NL 90/01

REACTOR COOLANT SYSTEM

3/4.4.6 PRESSURE/TEMPERATURE LIMITS

GRAND GULF-UNIT 1

FIGURE 3.4.6.1-1

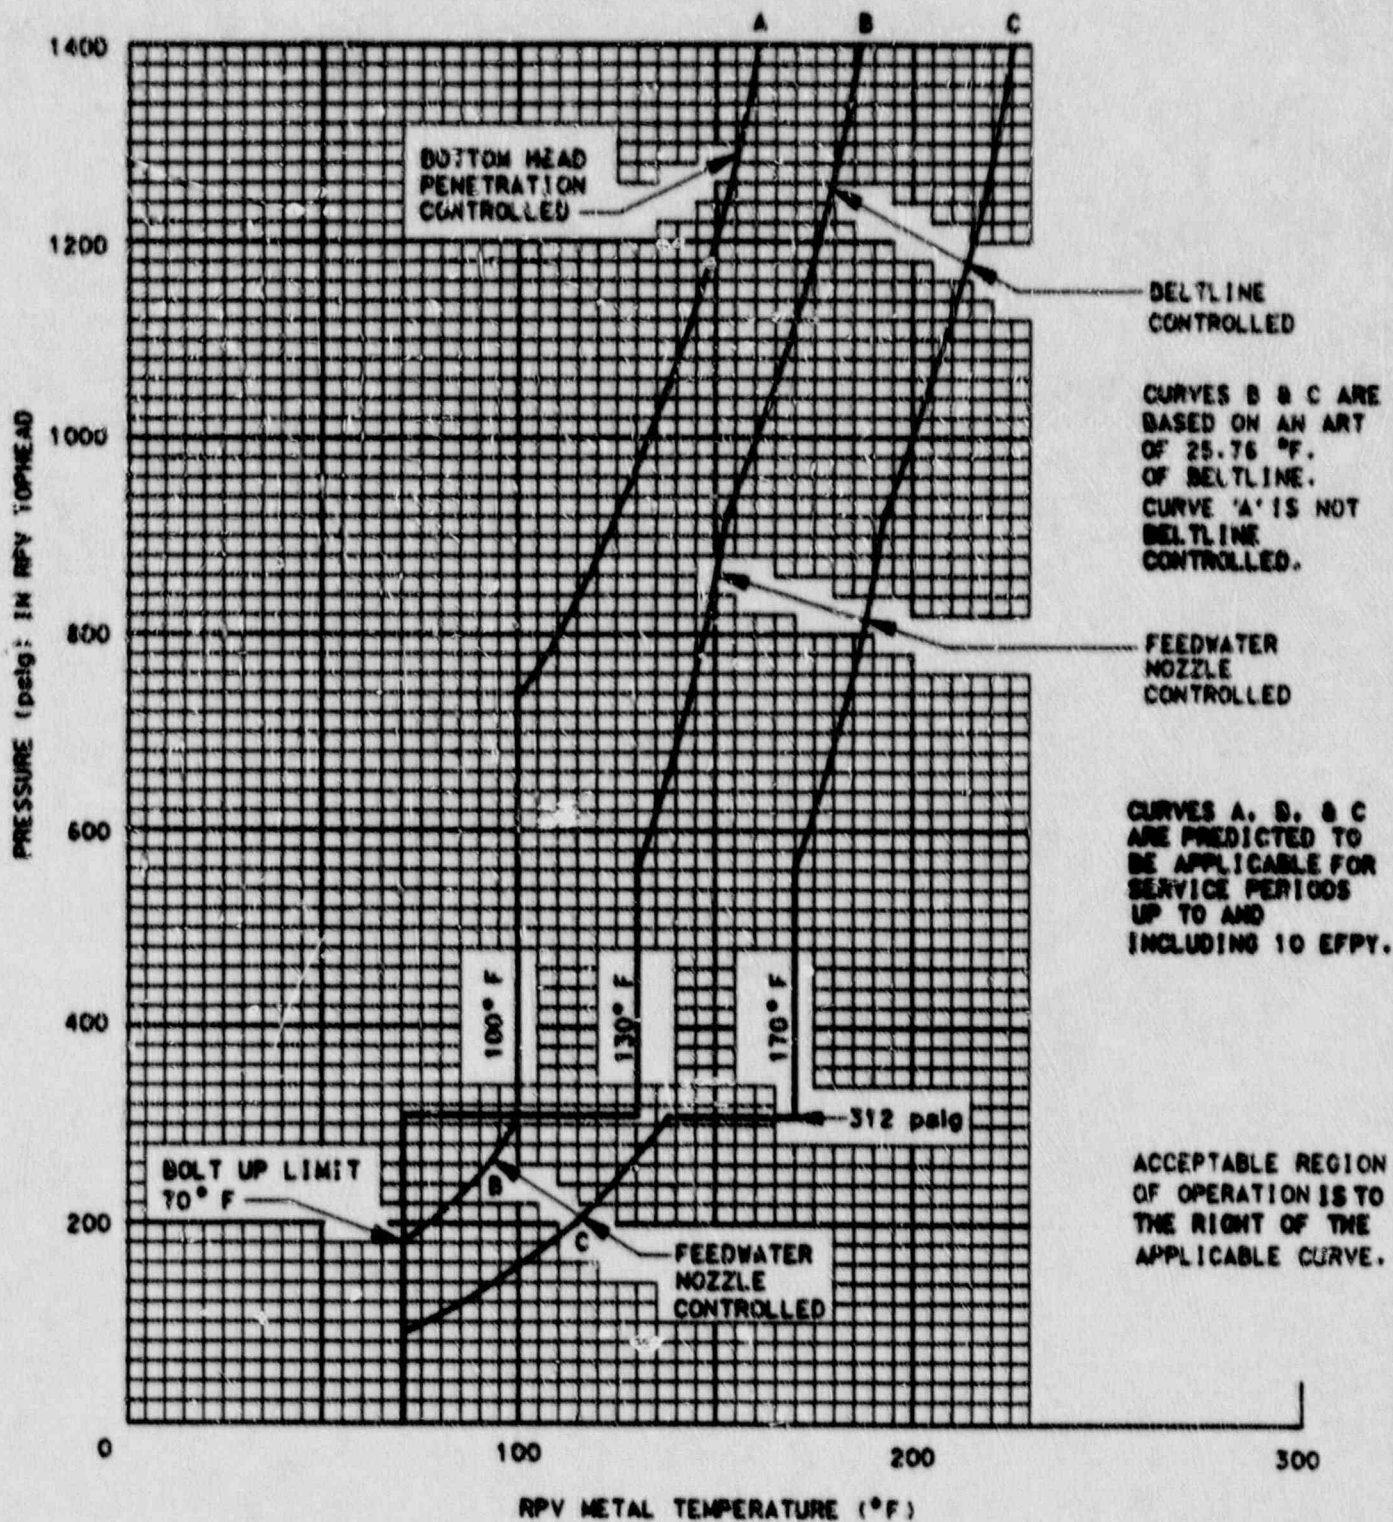
~~4.4.6.1.5 The reactor flux wire specimens shall be removed at the first refueling outage and examined to determine reactor pressure vessel fluence as a function of time and power level and used to modify Figure B-3/4.4.6-1. The results of the fluence determinations, in conjunction with Figure B-3/4.4.6-1, shall be used to adjust the curves of Figure 3.4.6.1-1, as required.~~

Delete this figure.
Replace with revised Figure 3.4.6.1-1

The Pressure-Temperature limit
Figure 3.4.6.1-1 is valid through 10 EFPYs
and shall be re-evaluated prior to exceeding
10 EFPYs.

BASES FIGURE B 3/4 4.6-1 FAST NEUTRON FLUENCE ($E>1$ MeV)
AT $1/4$ T AS A FUNCTION OF SERVICE
LIFE *

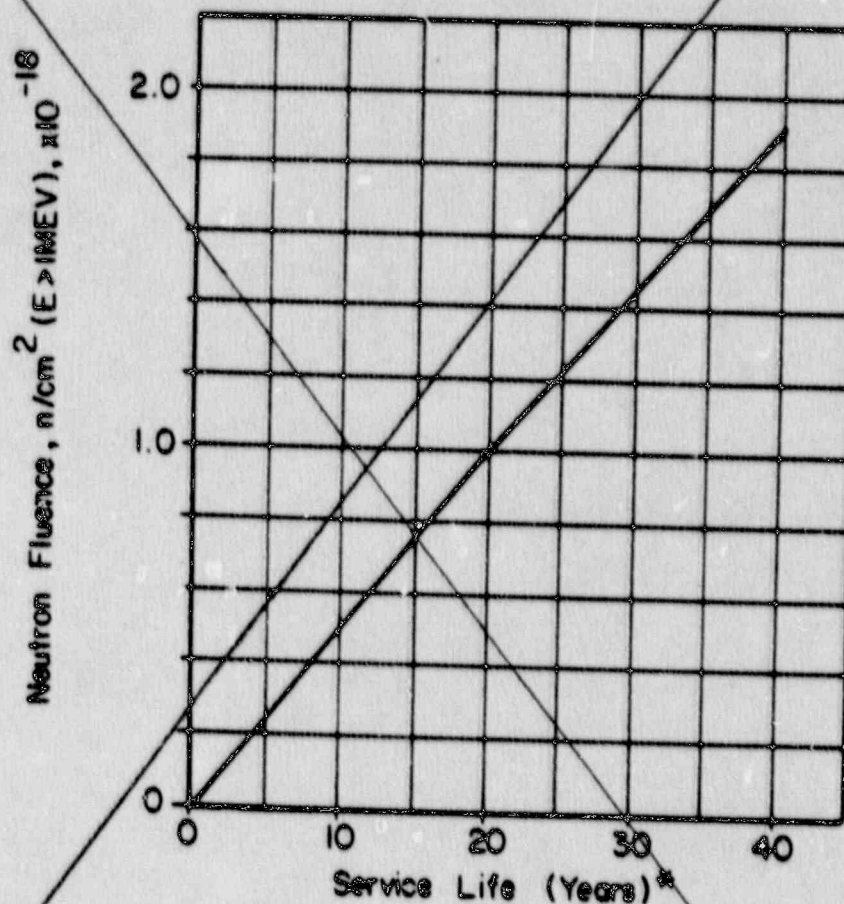
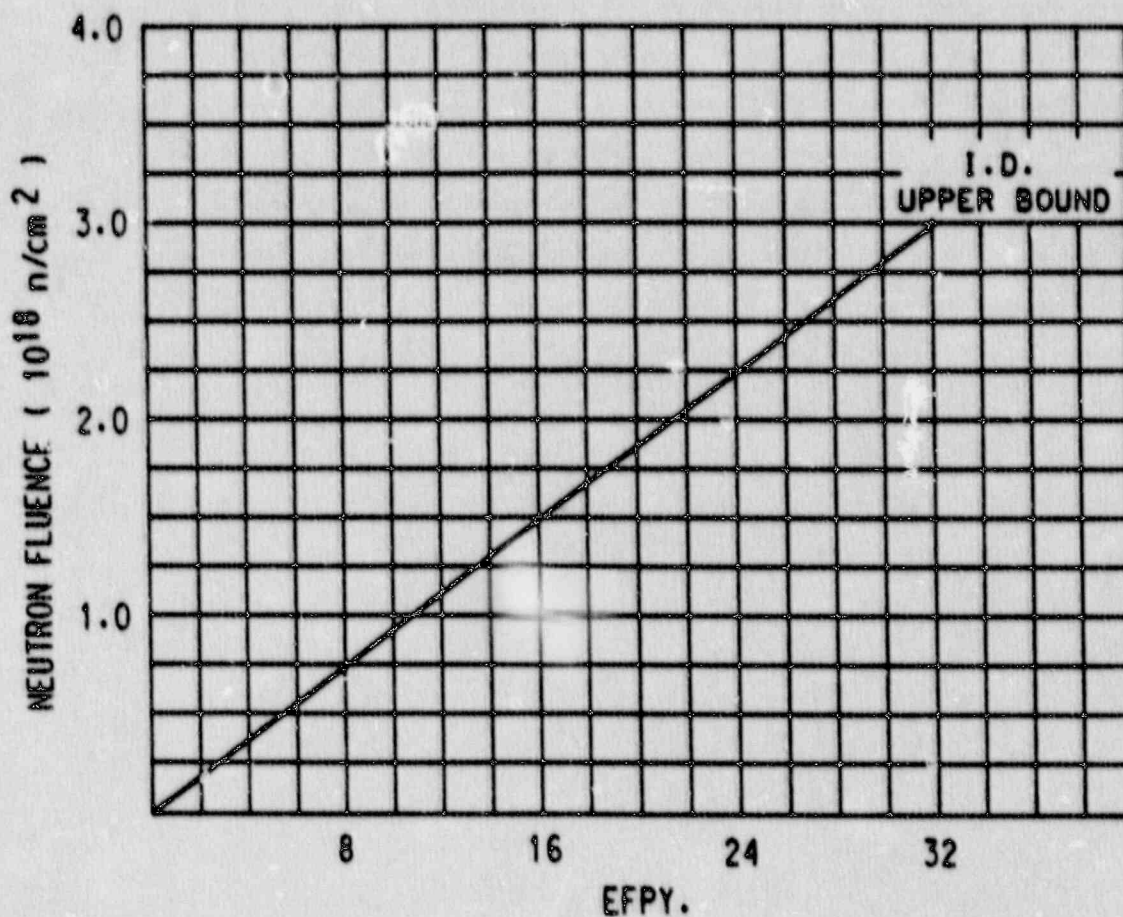
Bases Figure B 3/4.4.6-1 has been revised to reflect the analysis of the flux wire dosimeter which was removed during the first refueling outage. The upper bound curve B 3/4.4.6-1 was used in determining the Pressure-Temperature limit curves in Figure 3.4.6.1-1.

Delete this figure
Replace with revised
bases Figure B 3/4 4.6-1

BASES FIGURE B 3/4.4.6.1 FAST NEUTRON FLUENCE ($E > 1\text{MeV}$)
AT VESSEL I.D. AS A FUNCTION OF EFPY.
